文件编号 Document No.	ESP-07-2-007-03	文件名称 Document Name	产品/工艺变更通知 Product/Process Change Notice (PCN)
文件版本 Document Version	1.4	保存期限 Retention Period	5 年 5 years

ESP32-C2 (ESP8684) 系列产品由芯片版本: v1.0 升级为芯片版本: v1.1 Upgrade ESP32-C2 (ESP8684) Series from Chip Revision v1.0 to Chip Revision v1.1			
PCN 编号 PCN No.	PCN20230701	提出日期 Issue Date of PCN	2023/08/24
变更日期 Proposed Date of Change	2023/10/24	预计变更后产品首次出货日期 Proposed Date of First Shipment After Change	2023/11/24
PCN 类型 / PCN Category	☒ 客户需要批准/ Customer Approval Required ☐ 客户通知/ Customer Notification

6. 变更前后产品处理/ How to Deal with Products

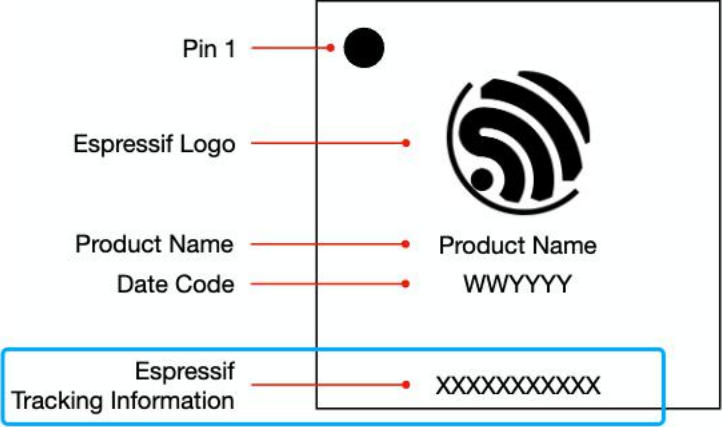
FIFO
